Access Compliance Report

Public Rights-of-Way

(Curb Ramps)

Intersection ID: 13408	Main Street: COMMONWEALTH_AV	Cross Street: THE_PLAZA	Location: S
ADA ID: D627E7D03CCD	Ramp Type: Directional1	Initial Pass/Fail: Pass	Overall Compliance: No
Codes/Mitigation Info/Possible Solution		Field Measurements/Component Compliance	
Severity Score: 10

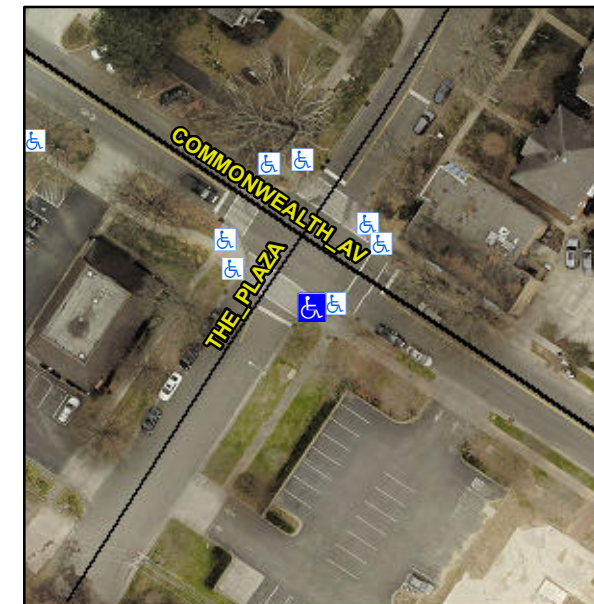
CURB GAP 1.0

**Not Found, R304.2.2-Perp, R304.3.2-
Para, R304.5.3, R305.1.4, R305.2,
R302.7.2**

Compliance	Description	Data	Compliance	Description	Data
N/A	Ramp Length (in)	99.5	Yes	Grade Break?	Yes
Yes	Ramp Width (in)	58.0	No	Grade Break Slope (%)	7.6
Yes	Ramp Slope (%)	5.8	Yes	Grade Break XSlope (%)	1.9
Yes	Ramp XSlope (%)	1.4			
Yes	Flare Type LT	N/A	Yes	Flare Type RT	N/A
N/A	Flare Slope LT (%)	N/A	N/A	Flare Slope RT (%)	N/A
N/A	Flare Traversable LT?	No	N/A	Flare Traversable RT?	No
Yes	Landing Length (in)	70.5	Yes	DWS Provided?	Yes
Yes	Landing Width (in)	67.0	Yes	DWS Contrast?	Yes
No	Landing Slope (%)	3.1	Yes	DWS Length (in)	24.0
No	Landing X Slope (%)	4.7	No	DWS Full Width?	No
N/A	Landing Curb? (Y/N)	N/A	No	DWS Offset LT (in)	3.0
N/A	Shared Landing?	Yes	Yes	DWS Offset RT (in)	33.5
Yes	Gutter Ponding?	No	Yes	Gutter Slope (%)	0.6
No	Gutter Lip Ht (in)	0.5	No	Gutter X Slope (%)	2.3
N/A	Painted X Walk1?	Yes		Road Slope (%)	4.1
	X Walk 1 Direction	To NW		Road X Slope (%)	3.4
	X Walk 1 Width (in)	135.0		Clear Space?	Yes

**Remove & Replace Entire Ramp.
Remove & Replace Gutter.**
